WORKING DRAFT OF CODE-MAKING **PANEL MEETING OUTPUT**

Document: National Electrical Code®

Revision Cycle: A2019

Committee Activity: Input Stage

Figure 210.52(C)(1) Determination of Area Behind a Range, Counter-Mounted Cooking Unit, or Sink.

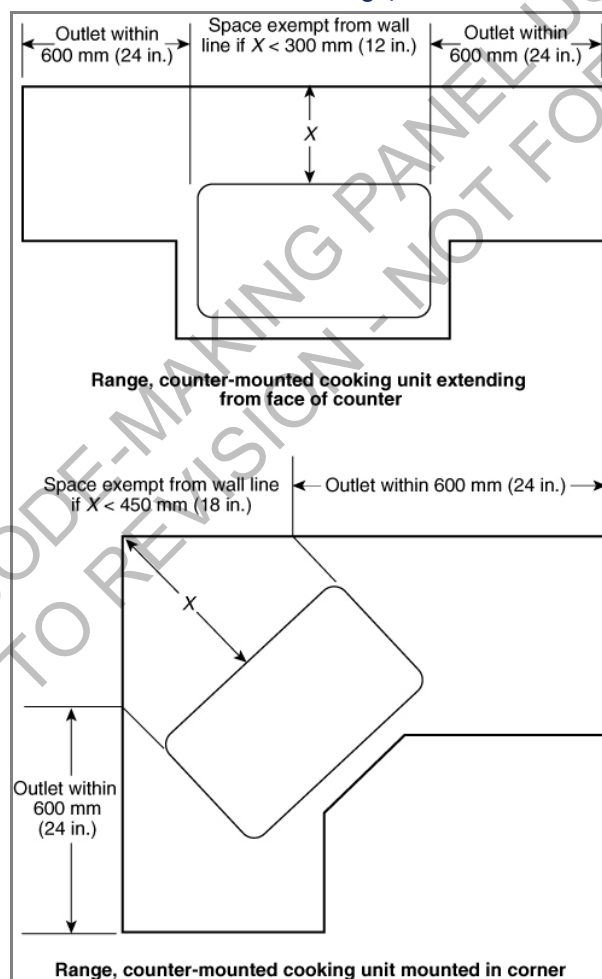
The word "sink" is added to the the labels under each figure to match the figure title. The figures are representative of the many different configurations of sinks and counters.

<u>Date</u>	<u>Submitted By</u>	
Jan 8, 2018	NEC-CMP Panel 02	Change note on figures from: Range, counter-mounted cooking unit extending from face of counter to: Range, counter-mounted cooking unit, or sink, extending from face of counter
Jan 8, 2018	NEC-CMP Panel 02	Change note on figure from: Range, counter-mounted cooking unit mounted in corner to: Range, counter-mounted cooking unit, or sink mounted in corner

Exception: Receptacle outlets shall not be required on a wall directly behind a range, counter-mounted cooking unit, or sink in the installation described in Figure 210.52(C)(1).
